# AP1000 TECHNICAL REPORT REVIEW

## Response to Request For Additional Information (RAI)

RAI Response Number: RAI-SRP9.1.2-SEB1-02  
Revision: 2A

RAI Response Number: RAI-TR44-009  
Revision: 2A

FIGURE TR44-9.2; ELEVATION VIEW OF  
NEW STORAGE RACK CELLS

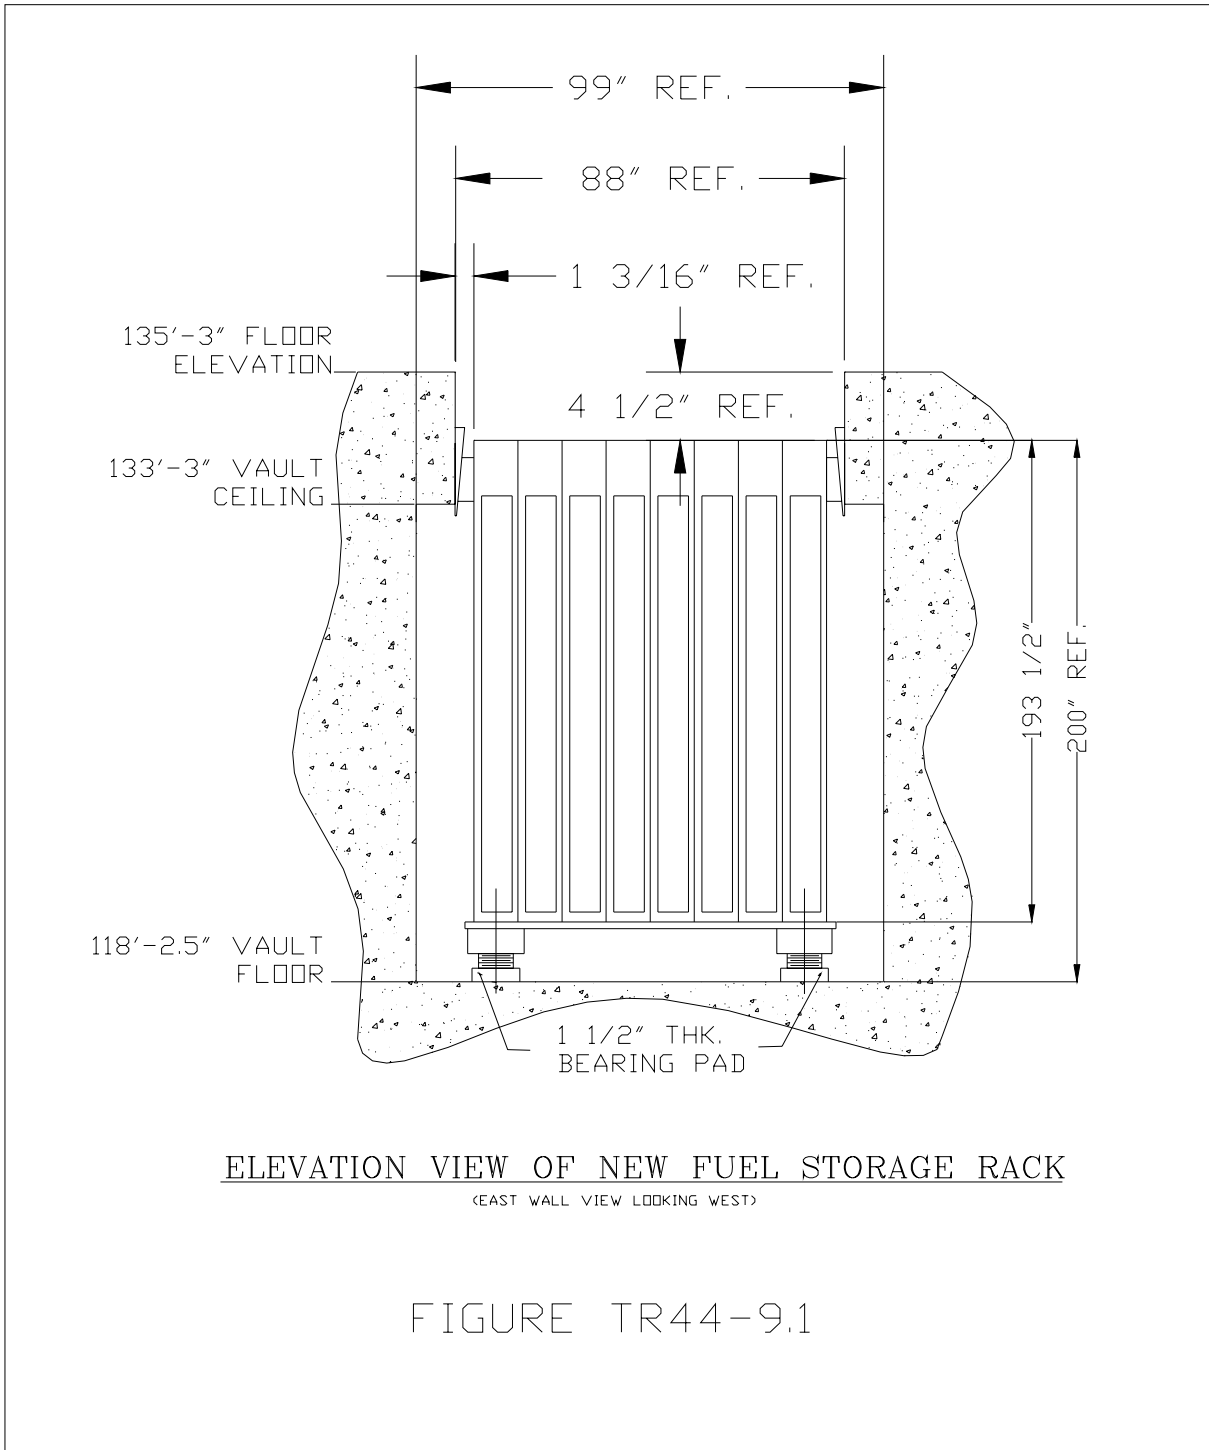
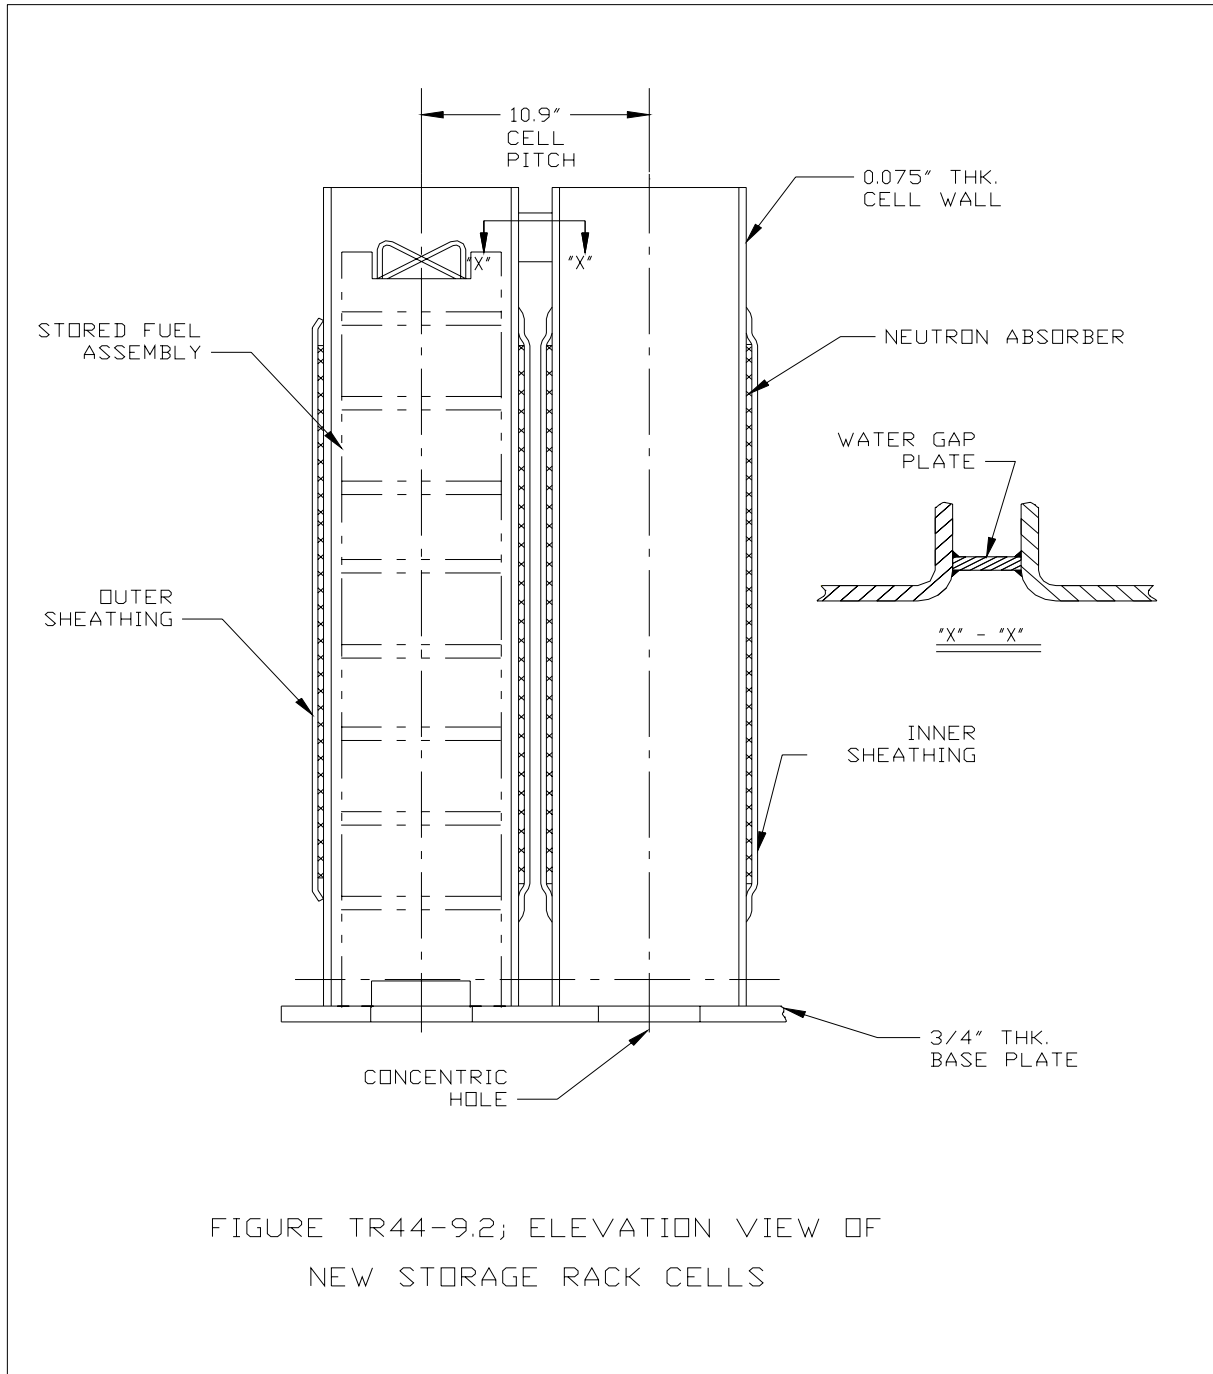
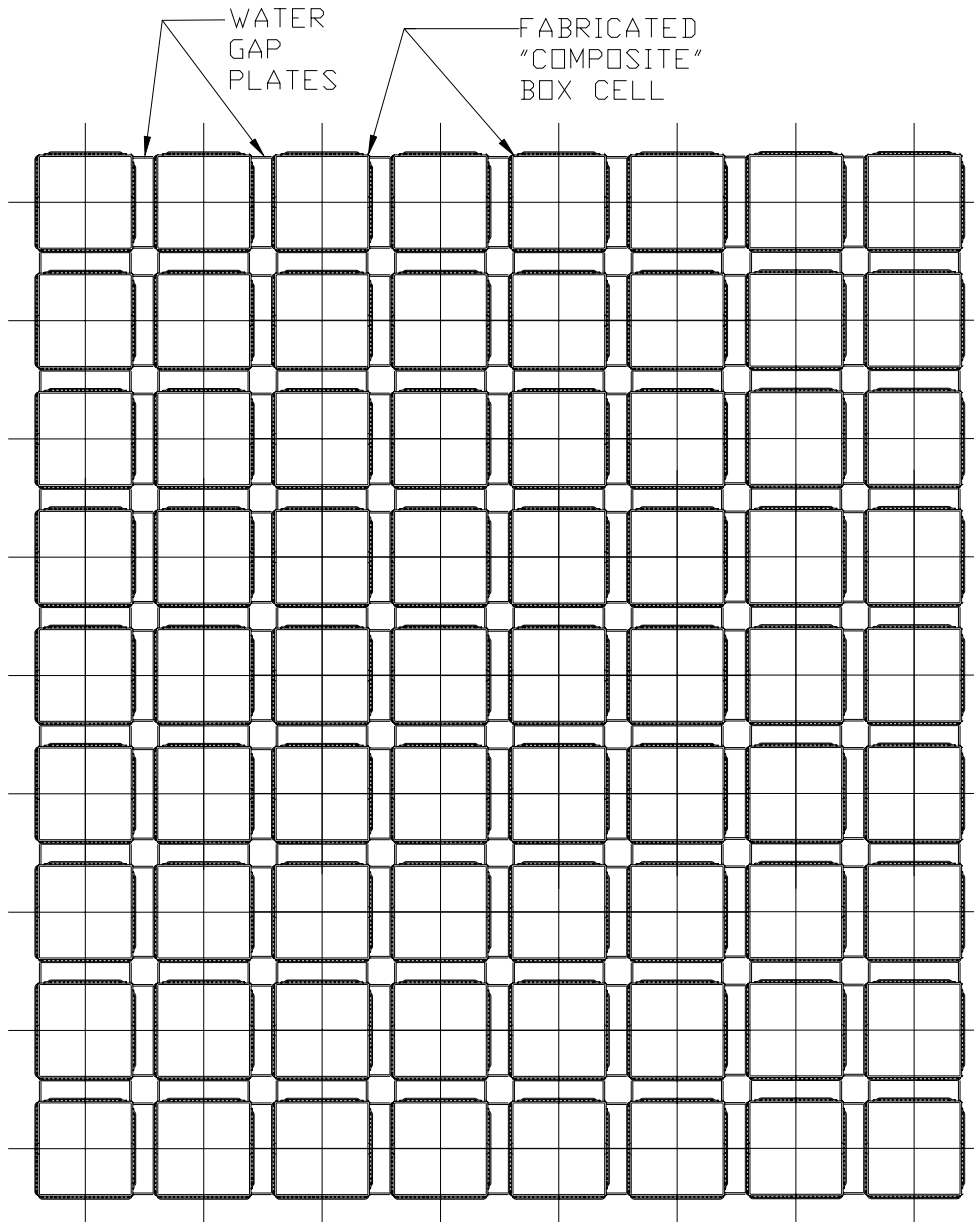
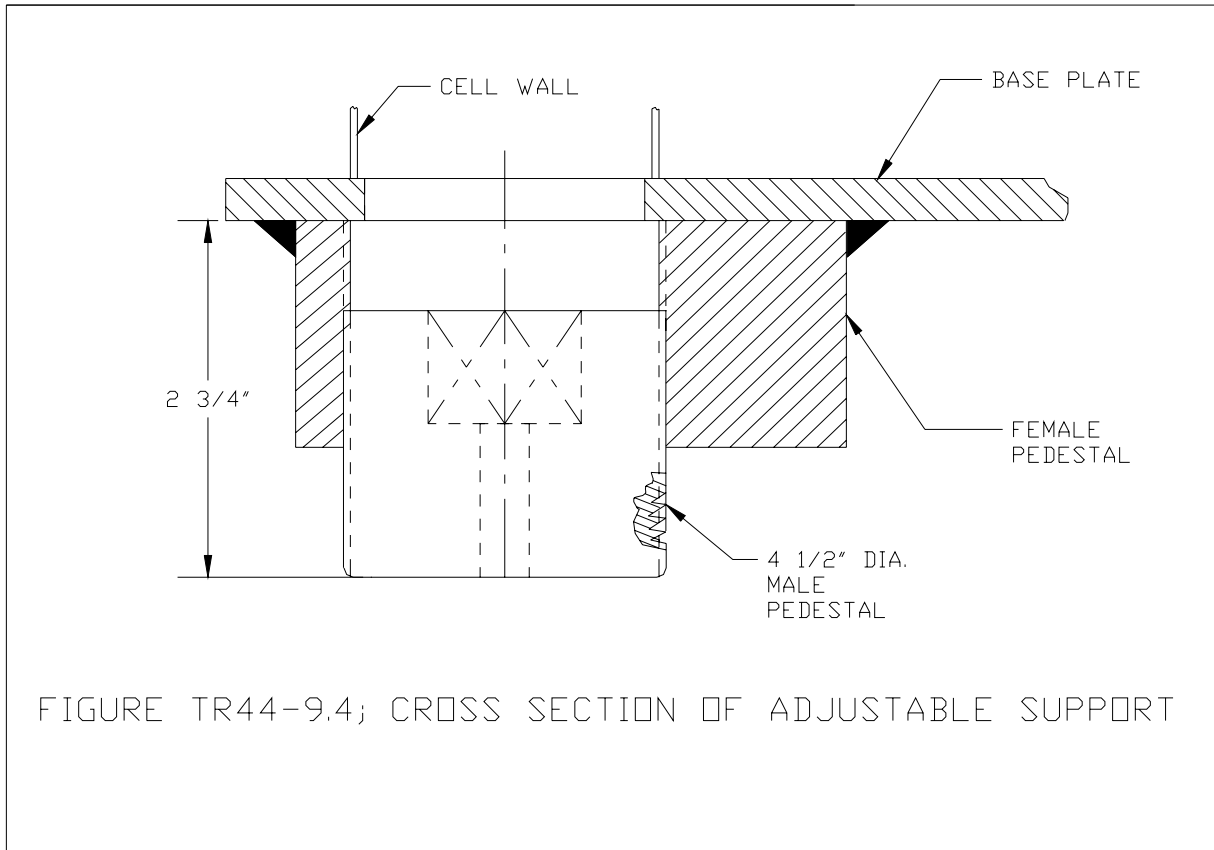
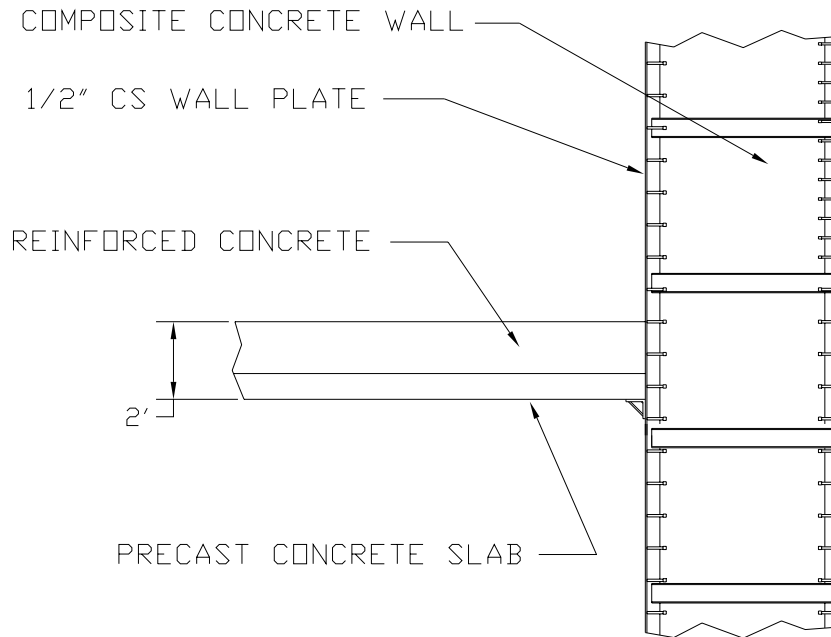
Insufficient descriptive information has been included in the new fuel report to permit an adequate review of the structural/seismic analysis of the new fuel rack. Please provide descriptive information including plans and sections showing the new fuel rack and vault walls. All of the major features of the rack including the cell walls, baseplate, pedestals, bearing pads, neutron absorber sheathing, any impact bars, welds connecting these parts, and any other elements in the load path of the rack should be shown on one or several sketches. These sketches should also indicate related information which includes key: cutouts, dimensions, material thicknesses, and gaps (fuel to cell, rack to walls). In addition to the above, for review of postulated fuel handling drop accident and quantification of the drop parameters, sketches with sufficient details for the fuel handling system should be provided.

During the June 2010 audit, the NRC requested that dimension and gap information for the new fuel racks be clarified between the three similar RAIs (RAI-TR44-09, RAI-TR44-017, RAI-TR44-25) to show consistency and alignment to the current design basis shown in DCD Figure 9.1-1.

Figures TR44-9.1 through TR-44-9.5 provide additional descriptive information on the new fuel rack and New Fuel Storage Pit floor and walls. The new fuel handling system is still in final design and no sketches are available. The quantification of the drop parameters has been established and analyzed in Technical Report Number 44. A conservative drop height of 36 inches has been assumed even though the most likely drop height will not exceed 18 inch above the new fuel rack. The total drop weight is 2,027 pounds, which consist of a new fuel assembly, control assembly and new fuel handling tool.
